**NOTICE OF DECISION TO CONSENT TO CHANGE TO PROPOSAL DURING  
ASSESSMENT**

Browse to North West Shelf (NWS) Project  
Assessment No. 2191

**STATEMENT OF REASONS**

**CONSENT TO CHANGE PROPOSAL DURING ASSESSMENT**

**Figure 1: Field Layout**

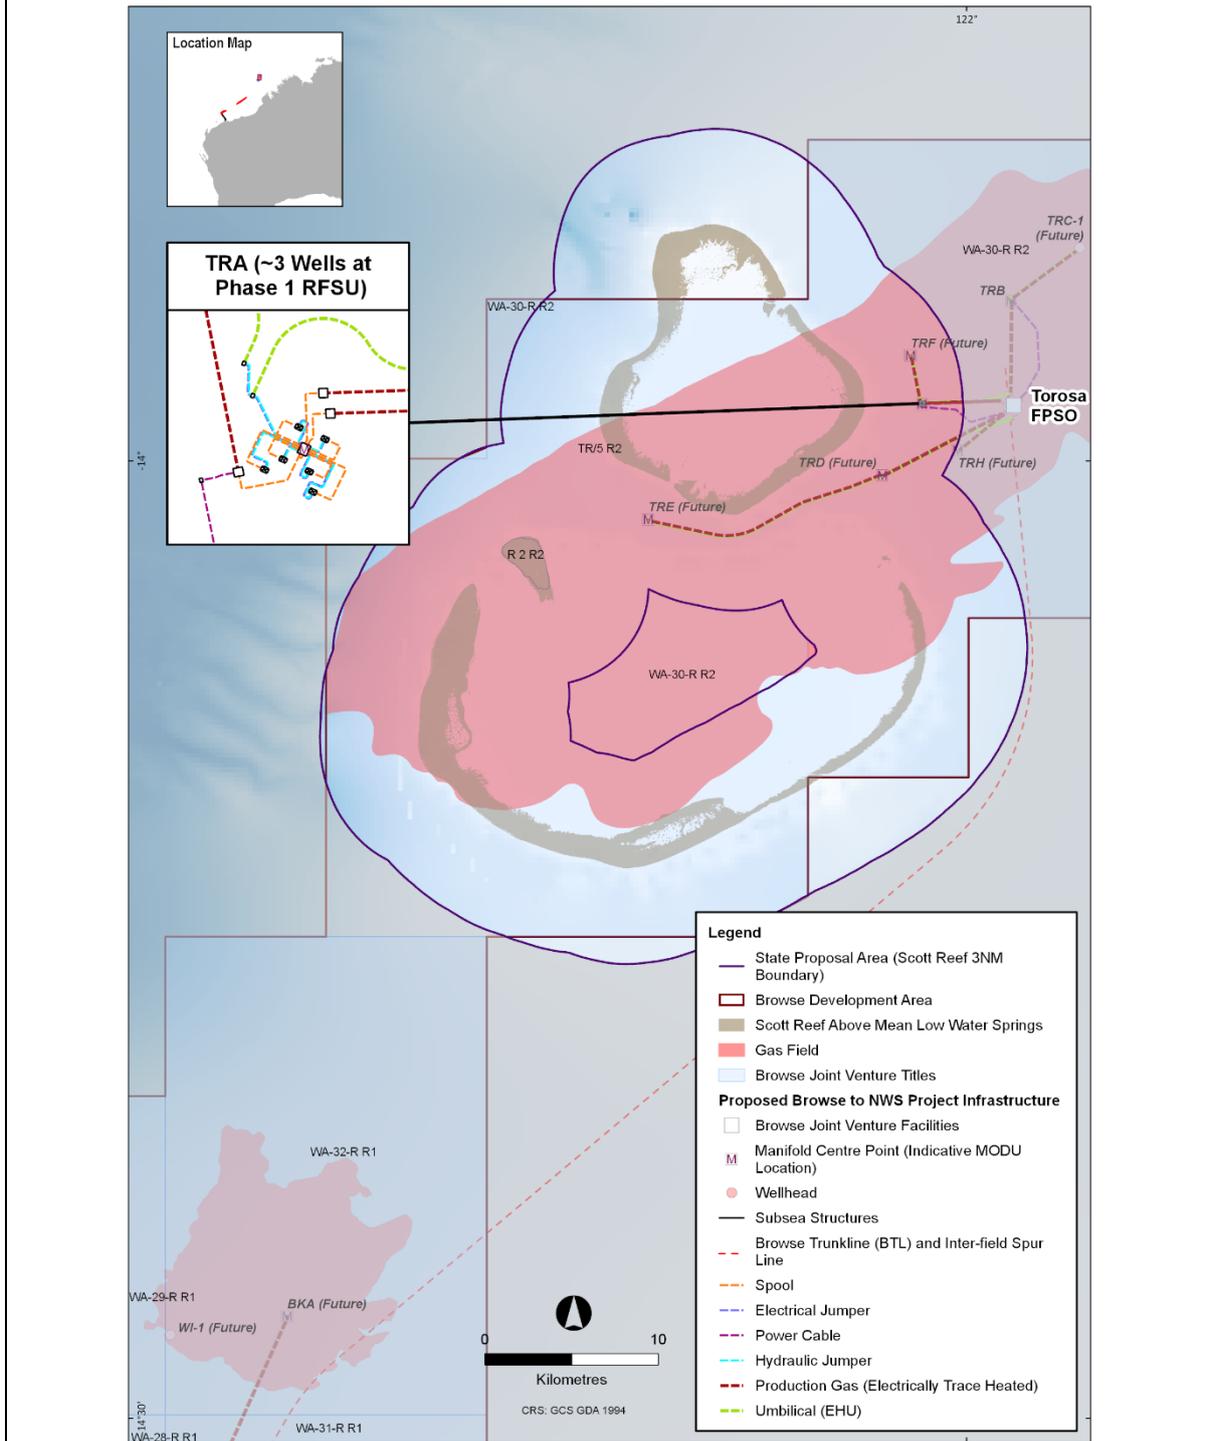
1. Increase in the number of drilling and completion activities of up to approximately 21 wells to 24 wells and an increase in drill cuttings discharges from 800 m<sup>3</sup> per well to 850 m<sup>3</sup> per well.
2. Increase in the direct seabed disturbance from approximately 20 ha of seabed to approximately 0.31 km<sup>2</sup> (31 ha) (including 25% contingency).
